SUBJECT: Proposed Amend 144b to License DPR-43, allowing laser-welded repair of Westinghouse hybrid expansion joint sleeved SG tubes. Non-proprietary & proprietary repts encl. Proprietary repts withheld.

Docket 50-305
Operating License DPR-43
Kewaunee Nuclear Power Plant
Proposed Amendment 144b to the Kewaunee Nuclear Power Plant Technical Specifications:
Laser Welded Repair of Degraded Westinghouse Hybrid Expansion Joint Sleeves

Proposed Amendment 144b

FIGURE 1

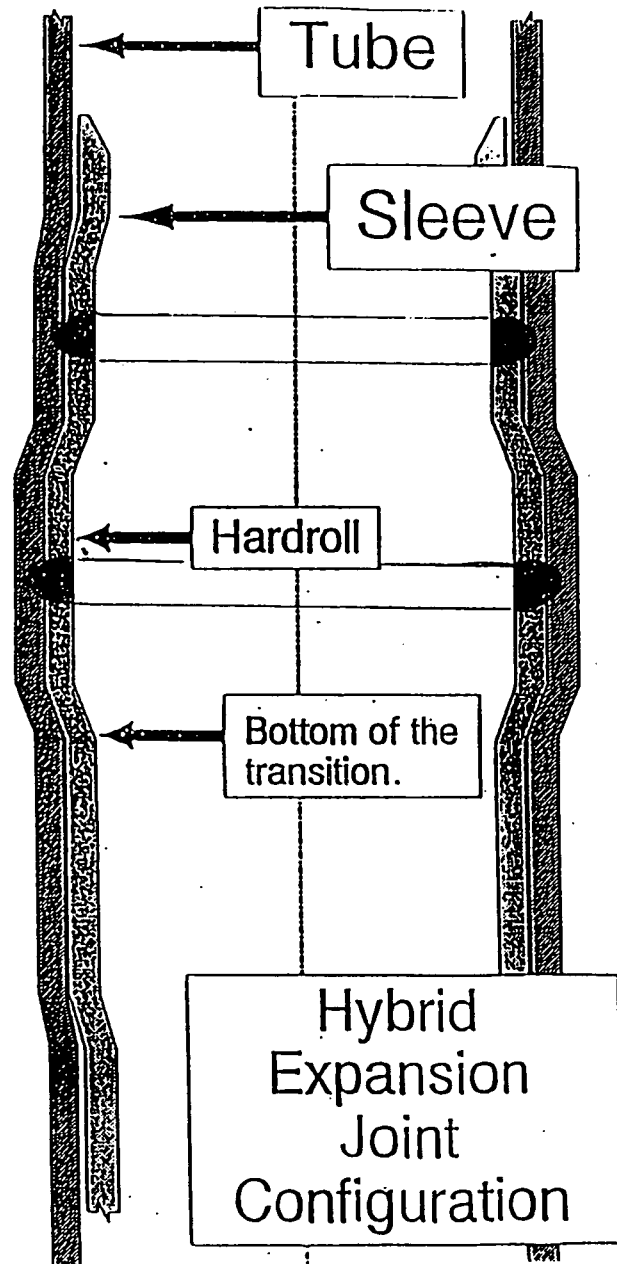
The proposed repair process, illustrated on Figure 1, is performed by fusing the parent tube and the sleeve using an autogenous laser welding technique. The repair weld is formed in either the approximate mid-point of the hardroll (HR), or in the upper hydraulic expansion (HE) of the upper HEJ. By fusing the sleeve to the tube, parent tube degradation below the weld location is isolated and a new pressure boundary is formed. The new pressure boundary (the weld) satisfies both the structural and leakage integrity requirements of the sleeved tube assembly with no change in the flow or heat transfer characteristics of the sleeved tube. Extensive testing and analytical work has been performed by WPSC and Westinghouse to demonstrate the acceptability of the LWR process. The results of this work are documented in the reports SGO-ATD-96-13, "Interim Report on Laser Weld Repair of Hybrid Expansion Joint Sleeves," dated April 4, 1996; WCAP-14685, Revision 2, "Laser Weld Repair of HEJ Sleeves for Kewaunee Nuclear Power Plant," dated April 1997; and Addendum 1 to WCAP-14685, "Evaluation of Weld Repaired HEJ Sleeved Tubes," dated April 1997.
